APPLICATION NO.	FILING DATE	FIRST NAMED INVENTOR	ATTORNEY DOCKET NO.	CONFIRMATION NO.
10/581,755	06/05/2006	Jiangqi He	10/581,755	8391
59796	7590	01/29/2010	EXAMINER	
INTEL CORPORATION c/o CPA Global P.O. BOX 52050 MINNEAPOLIS, MN 55402			NGUYEN, THINH T	
			ART UNIT	PAPER NUMBER
			2818	
			MAIL DATE	DELIVERY MODE
			01/29/2010	PAPER

Office Action Summary	Application No. 10/581,755	Applicant(s) HE ET AL.	
	Examiner THINH T. NGUYEN	Art Unit 2818

DETAILED OFFICE ACTION

FIG 4 OF AHN 042 DISCLOSURES

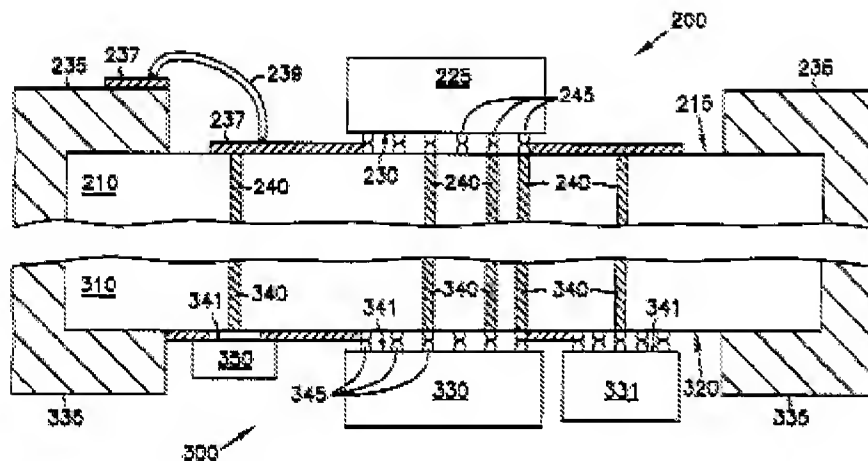
With regard to claim 4 , Ahn 042 discloses (fig 4) a microelectronic device wherein the second die disposed on a land side of the substrate (note that Ahn 042 discloses a land side on both surface of the substrate

With regard to claim 7, Ahn 042 discloses (fig 4) a microelectronic device further comprising a die including one selected from the group including a memory device, a memory controller, an application specific integrated circuit (ASIC), a graphics processor, a signal processor, a radio transceiver, and a combination thereof.

FIG. 7

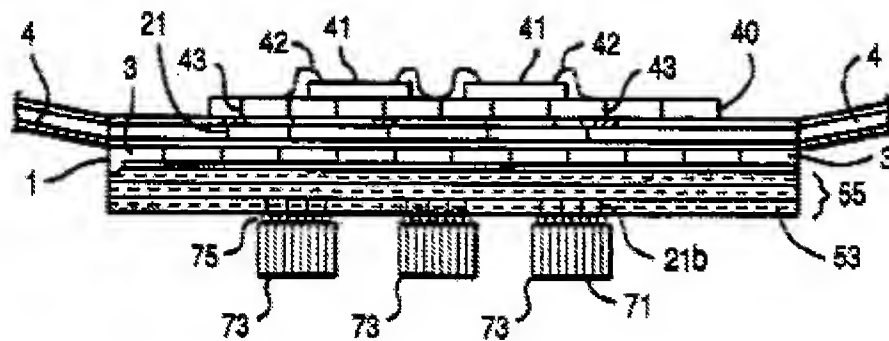
With regard to claim 1, Gilmour 917 discloses (fig 7,) a microelectronic device comprising: a package substrate having a first side and an opposing second side; a microprocessor adjacent to the first side of the package substrate(fig 7 element 41) and a memory device adjacent to the second side of the package substrate (fig 7 element 73) , wherein the package substrate is electrically coupled to at least one of the microprocessor and the memory device.

With regard to claim 4 , Gilmour 917 discloses (fig 7) a microelectronic device wherein the second die disposed on a land side of the substrate (note that Gilmour 917 discloses a land side on both surface of the substrate)

With regard to claim 7, Gilmour 917 discloses (fig 7,fig 9,fig 10,fig 11) a microelectronic device further comprising a die including one selected from the group including a memory device, a memory controller, an application specific integrated circuit (ASIC), a graphics processor, a signal processor, a radio transceiver, and a combination thereof.

FIG. 11

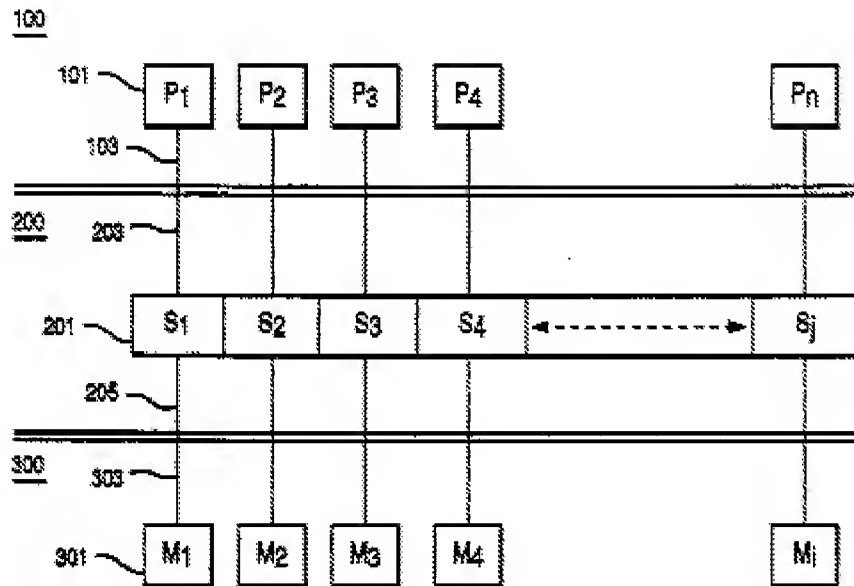
With regard to claim 5, Gilmour 917 discloses (fig 8, fig 10,fig 11) a microelectronic device further comprising a third die including a second microprocessor, a fourth die including a third microprocessor, and a fifth die including a fourth microprocessor.

With regard to claim 6, Gilmour 917 discloses (fig 8, fig 10,fig 11) second die electrically coupled by one selected from the group including a wire bond electrical interconnect, a flip-chip ball grid array electrical interconnect, a lead frame interconnect, and a combination thereof.
